Comments for Planning Application 26/00001/REM

Application Number: 26/00001/REM

Address: Land At West Cheltenham Southern Parcel Fiddlers Green Lane Cheltenham Gloucestershire

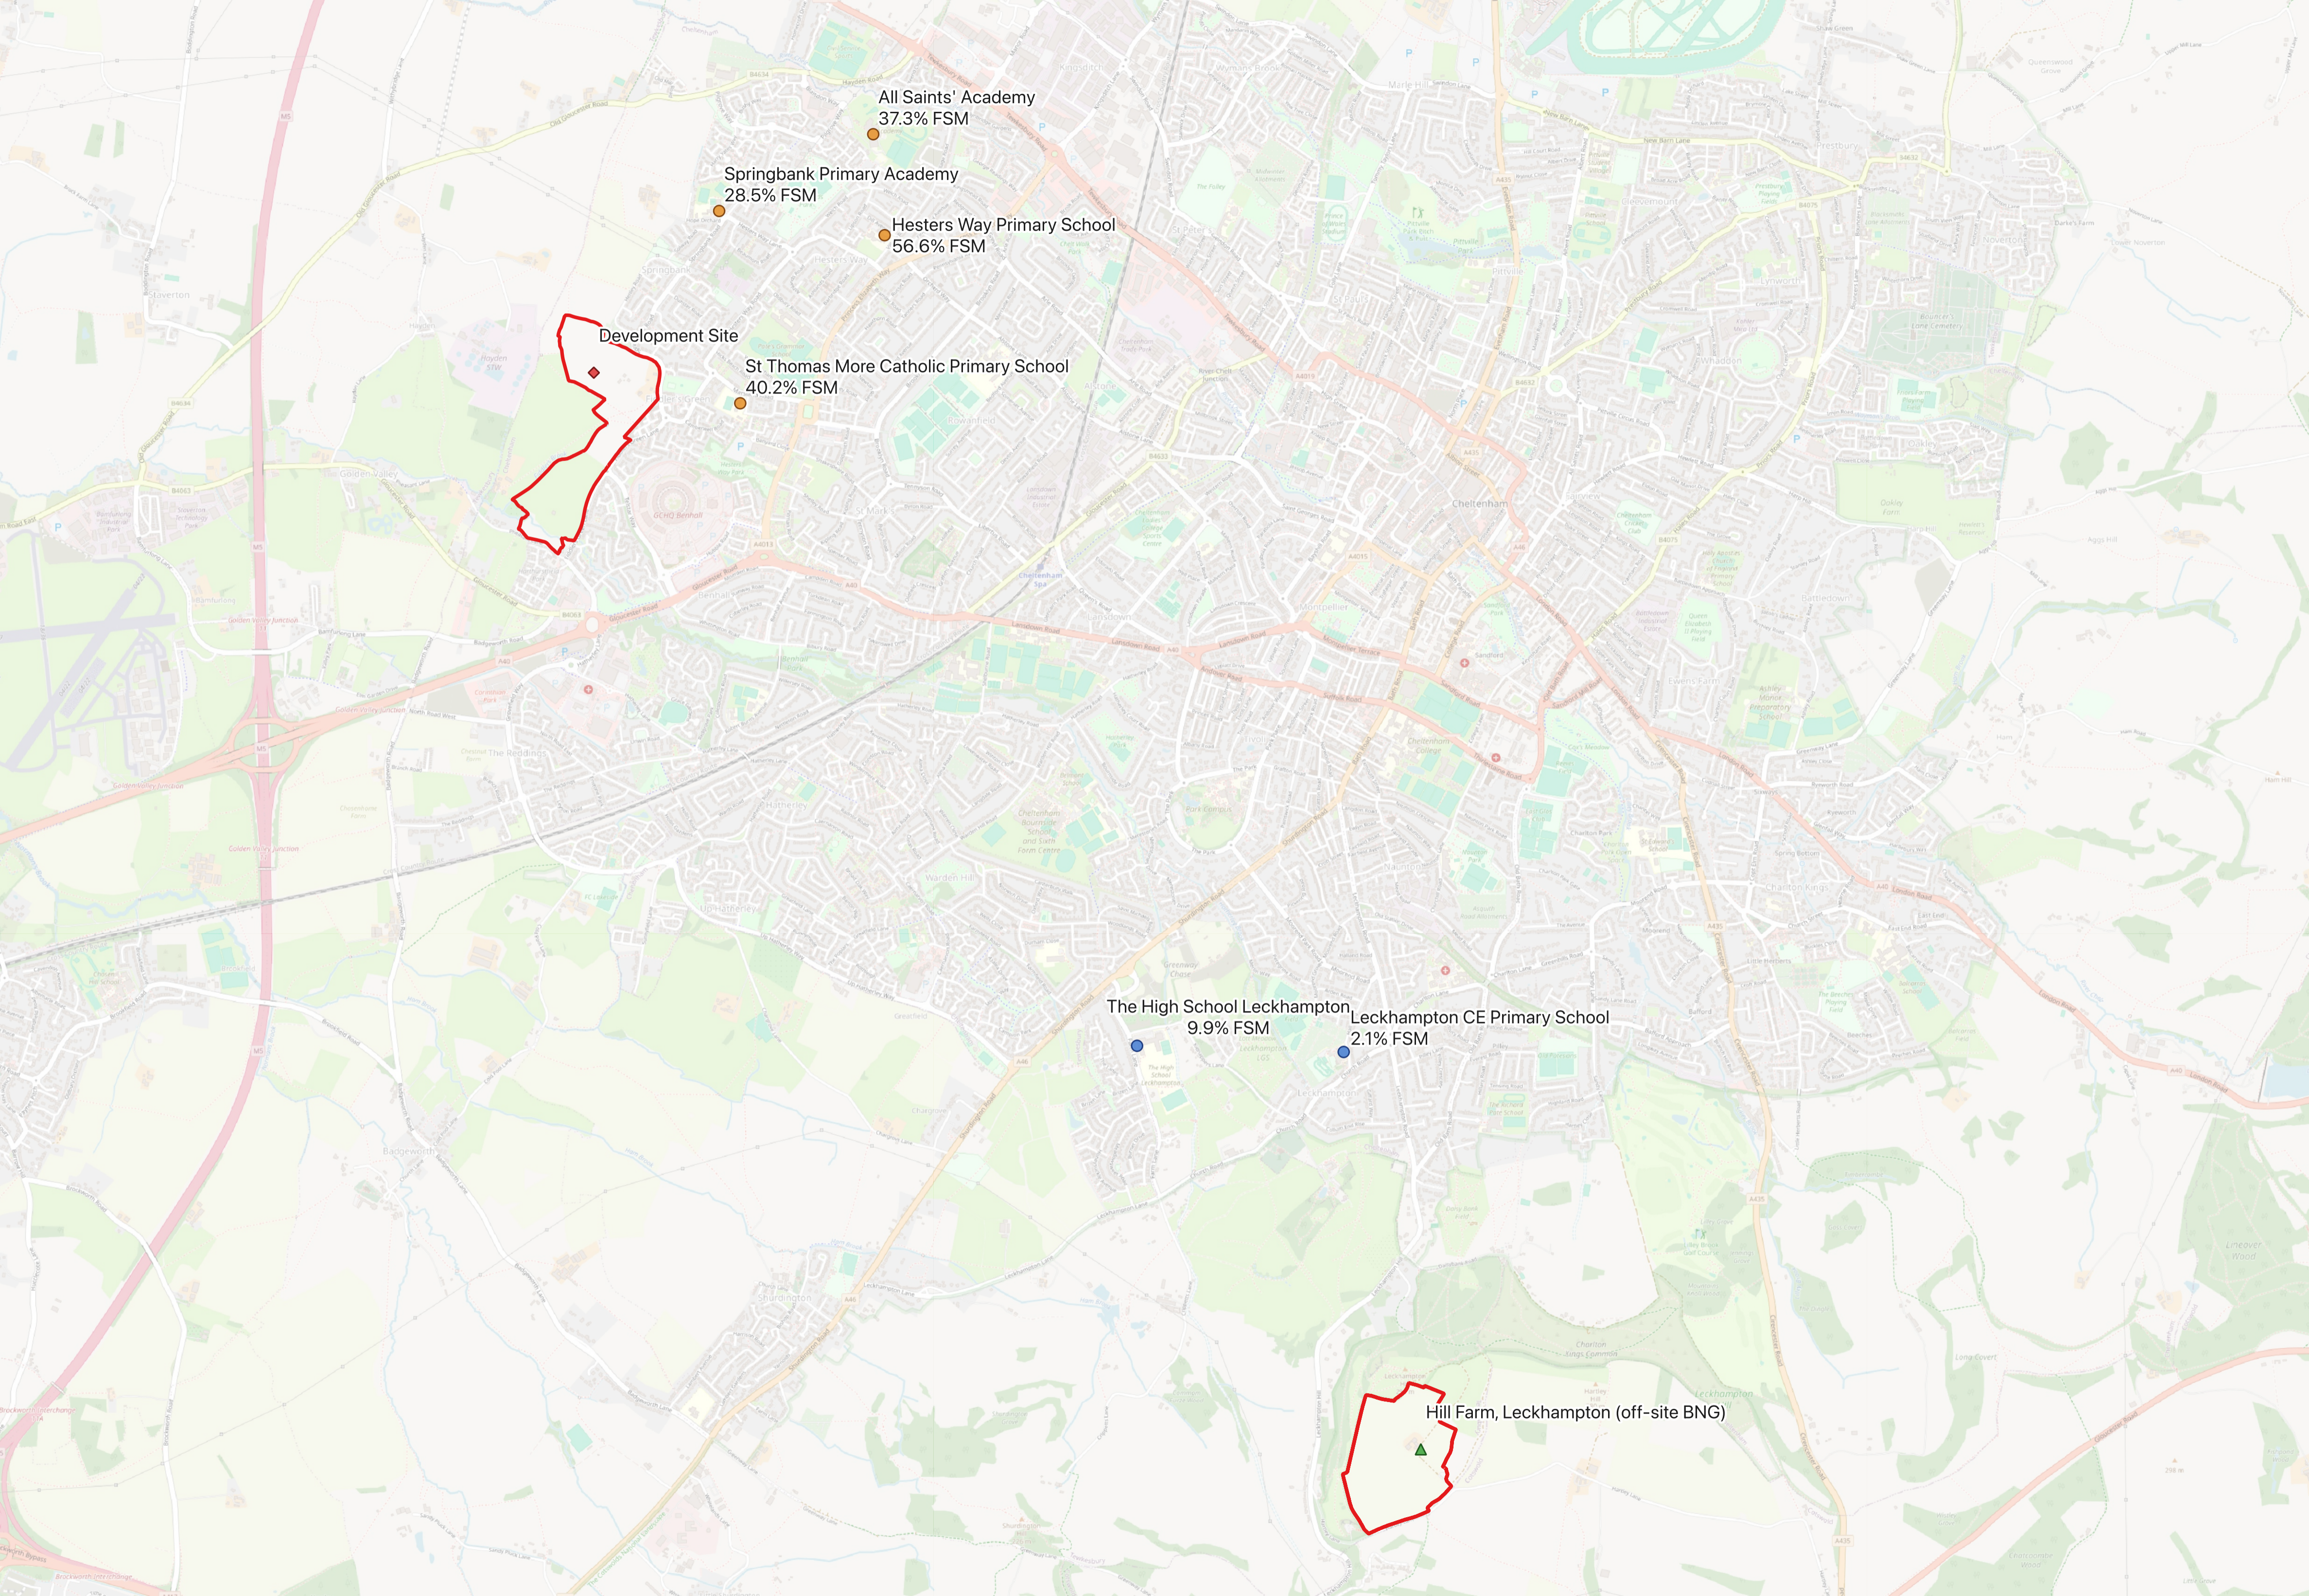
1. The deprivation gap between the community losing habitat and the community gaining it

The BNG strategy takes ecological and amenity value away from one of the most income-deprived child populations in the borough and delivers the compensating benefit to one of the least deprived. Department for Education data makes this very clear.

Hill Farm sits in the catchment of Leckhampton CE Primary School, where FSM eligibility is 2.10% ("low") and the local child deprivation rate within 2km is 4.9%. The High School Leckhampton, the nearest secondary, records 9.9%. The primary school next to Hill Farm has roughly one twenty-seventh of the FSM rate of the primary school next to the development site.

Under this proposal the compensating habitat gets created 5km away in a much less deprived part of the borough. I would ask the Council to consider whether this BNG strategy sits comfortably with its NPPF obligations around environmental inequality and with the public sector duty to advance equality of opportunity.

I ask that the application be refused or deferred until the applicant can show a revised BNG strategy that delivers the required net gain on-site or within West Cheltenham, not at Hill Farm. If officers are minded to recommend approval, I would urge that it go to Planning Committee so that elected Members can look at the environmental justice implications for Hesters Way and Springbank residents.
